Access Compliance Report

Public Rights-of-Way

(Curb Ramps)

Intersection ID: 53883	Main Street: PAW_VILLAGE_RD	Cross Street: PAW_CLUB_DR	Location: E
ADA ID: 33A7932495DD	Ramp Type: PerpDiag	Initial Pass/Fail: Fail	Overall Compliance: No
Severity Score: 8.75			
Codes/Mitigation Info/Possible Solution		Field Measurements/Component Compliance

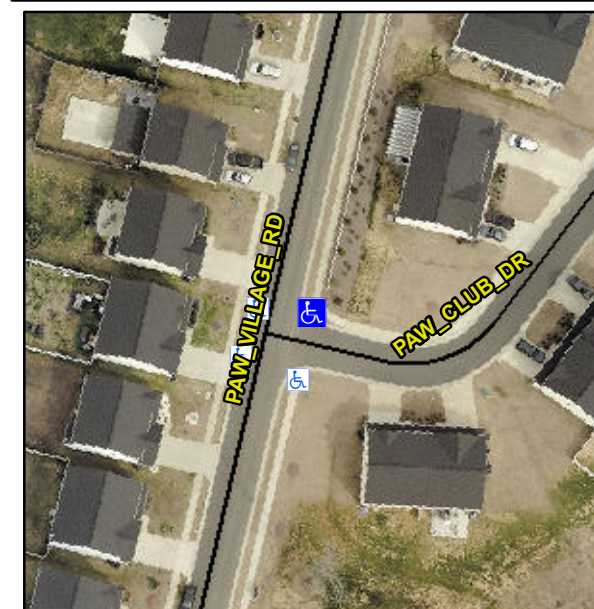
Not Found, R304.5.1

Compliance	Description	Data	Compliance	Description	Data
N/A	Ramp Length (in)	53.5	Yes	Ramp Slope (%)	5.8
No	Ramp Width (in)	47.5	Yes	Ramp XSlope (%)	0.6
N/A	Flare Type LT	N/A	N/A	Flare Type RT	N/A
N/A	Flare Slope LT (%)	N/A	N/A	Flare Slope RT (%)	N/A
N/A	Flare Traversable LT?	N/A	N/A	Flare Traversable RT?	N/A
N/A	Landing Length (in)	N/A	N/A	DWS Provided?	N/A
N/A	Landing Width (in)	N/A	N/A	DWS Contrast?	N/A
N/A	Landing Slope (%)	N/A	N/A	DWS Length (in)	N/A
N/A	Landing X Slope (%)	N/A	N/A	DWS Full Width?	N/A
N/A	Landing Curb? (Y/N)	N/A	N/A	DWS Offset (in)	N/A
N/A	Shared Landing?	N/A			
N/A	Gutter Ponding?	N/A	N/A	Gutter Slope (%)	N/A
N/A	Gutter Lip Ht (in)	N/A	N/A	Gutter X Slope (%)	N/A
N/A	Painted X Walk1?	No	N/A	Painted X Walk2?	No
	X Walk 1 Direction	To NW		X Walk 2 Direction	To SW
N/A	X Walk 1 Width (in)	N/A	N/A	X Walk 2 Width (in)	N/A
	X Walk 1 Slope (%)	4.0		X Walk 2 Slope (%)	4.6
	X Walk 1 X Slope (%)	4.2		X Walk 2 X Slope (%)	1.0

N/A	Ramp inside XWalk1?	N/A	N/A	Ramp inside XWalk2?	N/A
	Road Slope (%)	1.2	N/A	Clear Space?	N/A
	Road X Slope (%)	6.0	N/A	Clear Space to XWalk (in)	N/A
N/A	Any Obstructions?	N/A	N/A	Storm Grate/Utility Hazard?	N/A
	Obstruction Type			Storm Grate/Utility Type	
		N/A			N/A
		Yes		Surface Condition? (G/P)	Good

Remove & Replace Curb Ramp With Two New Directional Ramps or Equivalent.
